RE: PLANNING APPLICATION 2017 /4653/P

Flat 1, Ground Floor, 3 Akenside Road, London NW3 5BS

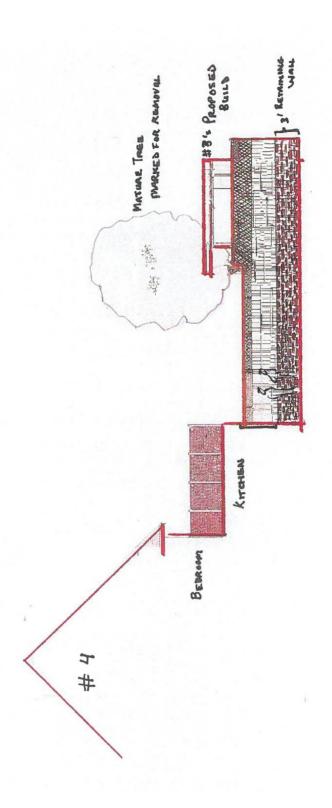
Nos. 4 and 5 are separated from no.3 by a retaining wall and fence which sets them significantly lower. They also have significantly shorter back gardens. The application will overlook their gardens, and any proposal to raise the fence between the properties will be resisted as it will exacerbate an already over-enclosed space. A sketch based in the applicants' section from the other side is attached along with a photograph of the application site from the kitchen at no.4.

Also attached is a site plan that shows that whilst the proposed building may be an acceptable distance from the application property, it is unacceptably close to the neighbouring properties.
